INITIAL FIRE SAFETY INSPECTION REPORT

Factory Name: Hydroxide Knitwear Ltd. (Extension)

RSC ID: 24560

Date: 23 May 2023

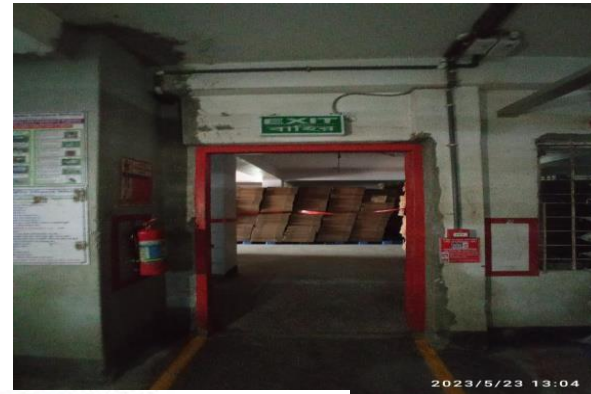
Sly No.	Category		Required Action	Remediation Time Frame
F-1	Fire Rated Construction	<p>Building-5: The exit stairs are not separated from work areas and other spaces on each floor by fire-rated construction.</p>	<p>Exits enclosure connecting three or fewer stories shall be enclosed with a minimum 1-hr fire-resistance rating. Exits enclosure connecting four or more stories shall be enclosed with a minimum 2-hr fire-resistance rating. Provide minimum 1-hr. (three or fewer stories) / 1.5-hr. (four or more stories) fire rated doors and seal all unprotected openings and penetration to separate the exit stairs from work areas and other building spaces on all floor levels. Ensure that the fire doors are self-closing and positive latching and that they are provided with fire exit (panic) hardware where serving production floors. If fire doors are required to be held open for functional reasons, provide automatic closing devices tied to the fire alarm system. Once fire doors are installed, every door in a stair enclosure serving more than 5 stories shall be provided with re-entry unless it meets RSC Technical Guidelines (standard) 6.8.3.1.</p>	Within 3 months
